Manual 12, Balancing Operations Revision 57 – Annual Review

PJM Operating Committee
March 12, 2026

Revision 57 (05/26/2026):

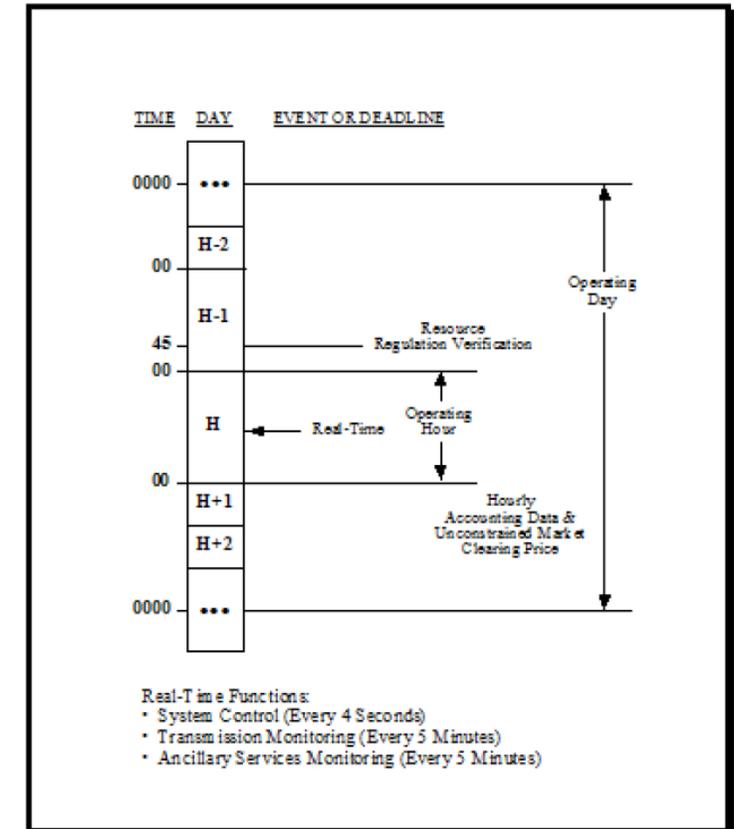
- Updated and reordered references:

- NERC Operating Manual
- [PJM Manual 1, Control Center and Data Exchange Requirements](#)
- [Transmission Operations](#) ~~PJM Manual 3,~~
- PJM Manual 10, [Pre-Scheduling Operations](#)
- PJM Manual 11, [Energy & Ancillary Services Market Operations](#)
- [PJM Manual 13, Emergency Operations](#)
- PJM Manual 28, [Operating Agreement Accounting](#)
- ~~PJM Manual 13, Emergency Operations~~
- [Regional Transmission and Energy Scheduling Practices](#)

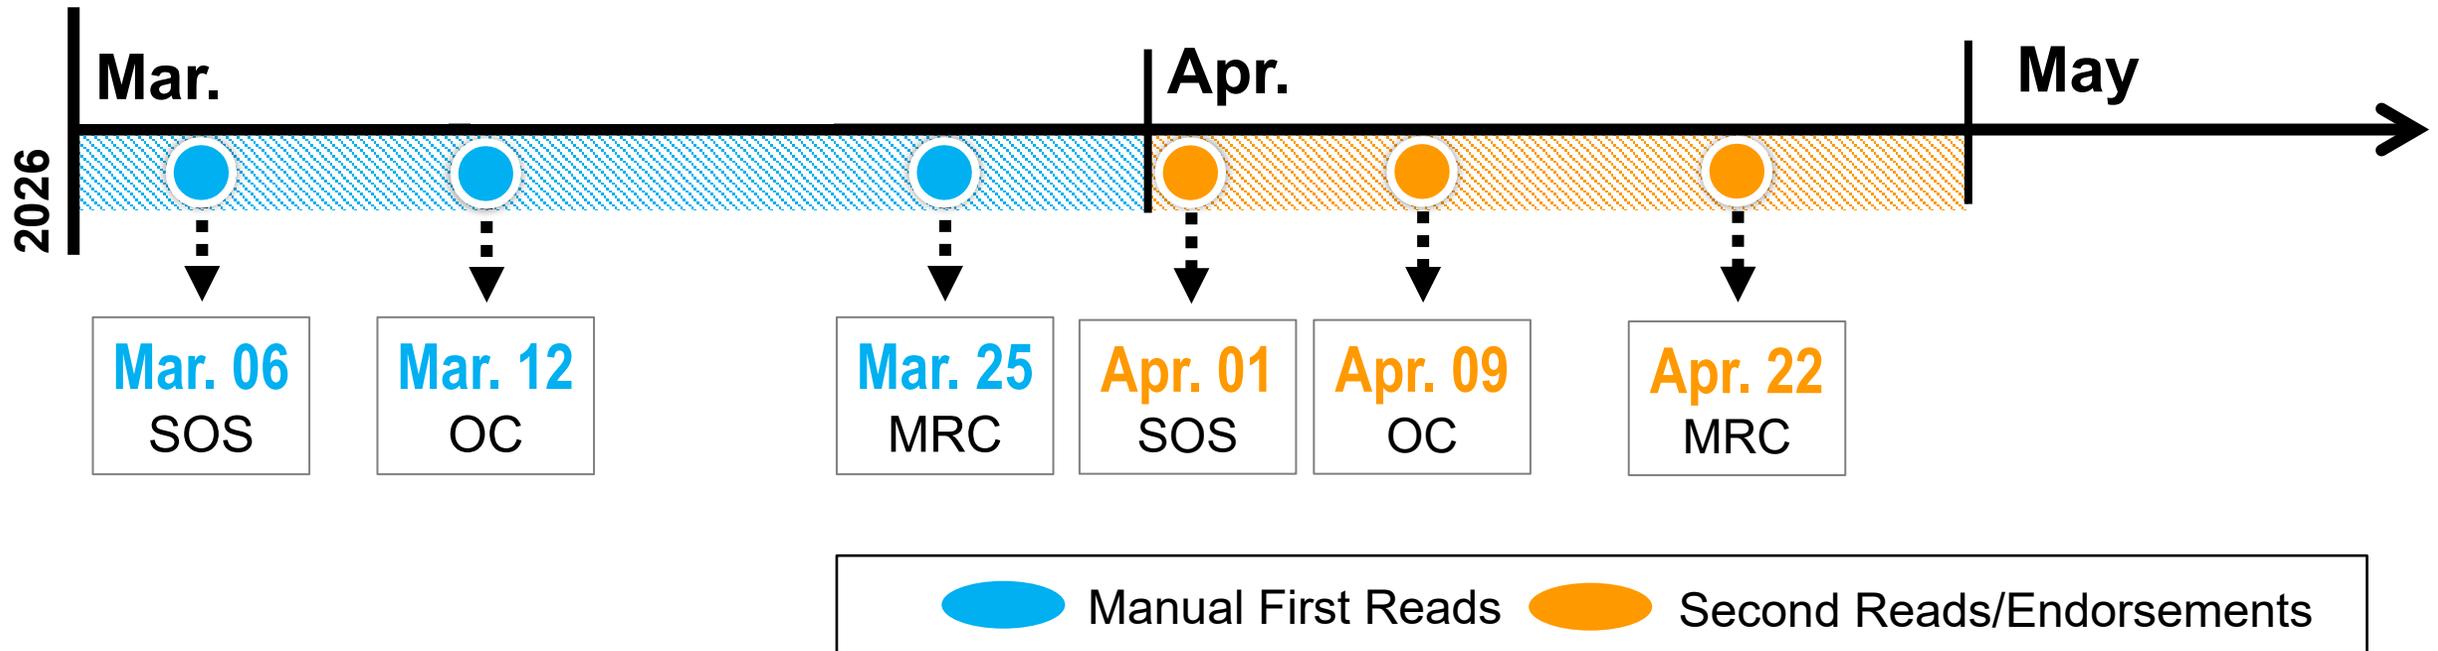
- Renamed Section 4.2 from Shared Reserves to Simultaneous Activation of Reserves (NPCC)
- Changed shared reserves to activated reserves in Section 4.2
- Removed specific control zones in Section 4.2

Simultaneous Activation of Reserves~~Shared Reserve Activation~~ is a procedure between the Northeast Power Coordinating Council (NPCC) and ~~the PJM Mid-Atlantic Control Zone (former MAAC region member companies)~~ to jointly activate a portion of their 10-minute reserve following any of the following situations:

- The NYISO supervising dispatcher assigns ~~the PJM-Mid-Atlantic-Control-Zone~~ a share of reserve pick-up. NYISO indicates the amount of participation.

- PJM dispatcher manually adjusts regulation, loads generation or Synchronized Reserve in selected areas or across the entirety of entire ~~PJM-Mid-Atlantic-Control-Zone~~ based on transfer limitations. This assistance is implemented at a zero-time ramp rate immediately following allocation notification. Response by assisting balancing areas shall respond as quickly as possible, assuming the same obligation as if the contingency occurred within the balancing area. This should be implemented via manually adjusting regulation if possible.
